3333 RAINIER AVE SOUTH -3002211
and
3340 CLAREMONT AVE S. -3008738

DESIGN REVIEW BOARD MEETING
A MIXED-USE COMMERCIAL & AFFORDABLE HOUSING PROJECT

Chubby & Tubby Affordable Workforce Housing

**EARLY DESIGN GUIDANCE
OF THE
SOUTHEAST DESIGN REVIEW BOARD**

PREFERRED DESIGN ALTERNATE 3 :

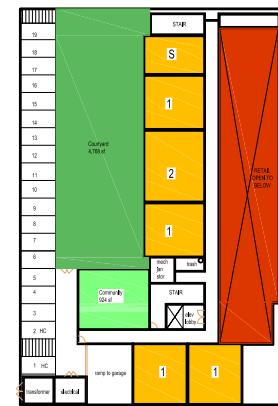
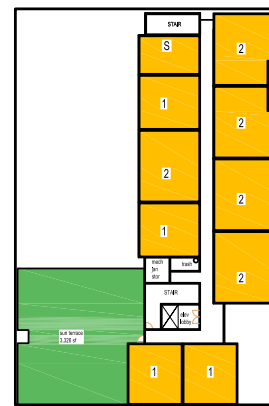
PARKING, MINI-WAREHOUSES, WAREHOUSES, OR UTILITY USES MAY NOT ABUT A STREET-LEVEL STREET-FACING FACADE IN A STRUCTURE THAT CONTAINS MORE THAN ONE RESIDENTIAL DWELLING UNIT. **DEPARTURE REQUEST FOR UTILITY USES ALONG S. WALDEN STREET NEAR ALLEY INTERSECTION**
 --SLOPING FRONTAGE ALONG S. WALDEN STREET IS NOT CONDUCTIVE TO COMMERCIAL OR RESIDENTIAL FRONTAGE. X DEPARTURE NOT SUPPORTED BY BOARD

ACCESS TO PARKING MUST BE FROM THE ALLEY IF THE LOT ABUTS AN ALLEY IMPROVED TO THE STANDARDS OF SECTION 23.53.030C. **DEPARTURE REQUEST TO ALLOW ACCESS TO PARKING OFF OF S. WALDEN ST.**
 --GARAGE ENTRY POINT OFF S. WALDEN ST. IS MOST EFFICIENT DUE TO UPHILL SLOPE TO ALLEY ACCESS. X DEPARTURE NOT SUPPORTED BY BOARD

15 FEET FOR PORTIONS OF STRUCTURES ABOVE 13 FEET IN HEIGHT TO A MAXIMUM OF 40 FEET; ONE-HALF OF THE ALLEY WIDTH MAY BE COUNTED AS PART OF THE REQUIRED SETBACK. **DEPARTURE REQUEST TO ALLOW 11' SETBACK ON C1-65 LOT WITH ADDITIONAL SETBACK ON L3 LOT TO PROVIDE REQUIRED SEPARATION.
 --4 STORY BUILDING HEIGHT ON C1-65 IS COMPATIBLE WITH 3 STORY TOWNHOMES ✓ DEPARTURE SUPPORTED BY BOARD

SURFACE PARKING ABUTTING OR ACROSS AN ALLEY FROM A LOT IN A RESIDENTIAL ZONE MUST HAVE SIX (6) FOOT HIGH SCREENING ALONG THE ABUTTING LOT LINE(S) AND A FIVE (5) FOOT DEEP LANDSCAPED AREA INSIDE THE SCREENING. **DEPARTURE REQUEST TO ALLOW SURFACE PARKING OFF ALLEY**
 --PARKING REQUIREMENT WAIVED IN STATION OVERLAY DISTRICT- HOWEVER, SURFACE PARKING OFF ALLEY ALLOWS FOR CONVENIENT COMMERCIAL PARKING (GARAGE CAN BE SECURED FOR RESIDENTS) AND WILL LESSEN THE DEMAND ON STREET PARKING. ✓ DEPARTURE SUPPORTED BY BOARD

QUANTITY OF OPEN SPACE: TO ALLOW A REDUCTION OF REQUIRED OPEN SPACE FROM AN AVERAGE OF 300 SF PER UNIT TO AN AVERAGE OF APPROX. 280 SF.
 RELATIONSHIP TO GRADE: TO ALLOW ACCESS TO THE OPEN SPACE TO BE FROM THE FRONT DOOR AND / OR ENTRY STAIRS. ✓ DEPARTURE SUPPORTED BY BOARD

PARCEL A - C1-65

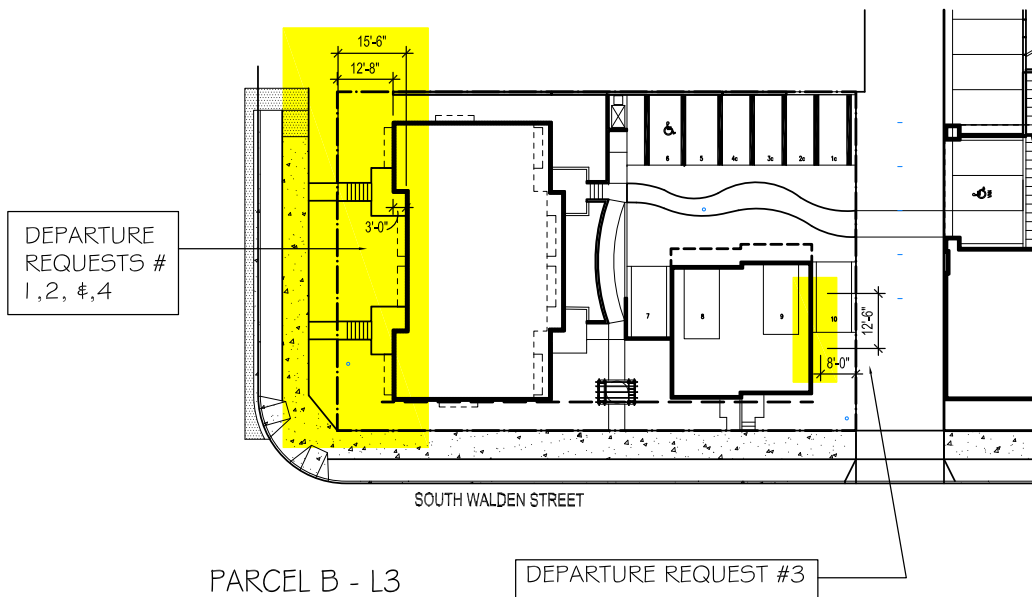
- The Board generally liked the preferred concept for the large building but did not like the access to the parking from South Walden that requires two curbcuts close together (structured parking entrance and the alley). Neither did they like the parking access located just inside the alley entrance as shown on the other two alternatives. Both of these access solutions detract from an active façade on South Walden. The Board recommends that the applicant explore locating the access to the below grade parking at the north end of the building off the alley.

- The Board feels that the South Walden St. façade is very important and want to see a more active, usable streetscape which reduces the blank walls and increase transparency (windows). As this project lies within the McClellan Station Area overlay district, it is likely that South Walden will become a major pedestrian corridor. They recommend that part of this façade be pulled back (even 5 feet) from the street to make a smoother transition to the related L-3 project across the alley. Even though the grade rises from Rainier Ave South along South Walden there is potential for residential uses at the alley edge. The utility functions and parking access should be relocated away from South Walden.

- Though the Board likes the plaza idea they feel that, in this case, it weakens what should be a stronger corner for the building. They feel that locating the residential entry with the retail entry at the corner could create potential conflicts. The Board recommends moving the residential entry around the corner onto South Walden St.

- ① PARKING GARAGE ACCESS IS NOW LOCATED OFF OF NORTH END OF ALLEY TO PROVIDE MAXIMUM OPPORTUNITIES FOR A PEDESTRIAN FRIENDLY ENVIRONMENT ON S. WALDEN STREET.

- ② RESIDENTIAL USES HAVE BEEN PROVIDED ALONG THE WEST PORTION OF THE WALDEN FACADE OF THE C1-65 BUILDING. THIS PORTION OF THE BUILDING IS SETBACK FROM THE SIDEWALK TO PROVIDE LANDSCAPING AND A TRANSITION TO THE LOWER DENSITY BUILDINGS ON THE ADJACENT L3 SITE.

- ④ THE PROPOSED COMMERCIAL PLAZA IS NOW ASSOCIATED WITH A LARGE CORNER COMMERCIAL TENANT AND IS SEPARATED FROM THE RESIDENTIAL LOBBY ENTRY. THE PLAZA WILL PROVIDE OPPORTUNITIES FOR AN ACTIVE STREETScape AND PROVIDE "EYES ON THE STREET" SECURITY. THE ADJACENT RESIDENTIAL LOBBY ALSO HAS LARGE WINDOWS FRONTING ONTO THE COMMERCIAL PLAZA.

- ⑤ A CONNECTION HAS BEEN PROVIDED FOR THE RESIDENTS OF THE L3 SITE TO UTILIZE THE OPEN SPACE & AMENITIES OF THE C1-65 BUILDING. THE PATH ACROSS THE ALLEY LEADS DIRECTLY TO THE SECURED COURTYARD GATE AS WELL AS THE REAR ENTRANCE OF THE BUILDING, LEADING TO THE COMMUNITY ROOM AND ELEVATOR TO THE ROOF TERRACE.
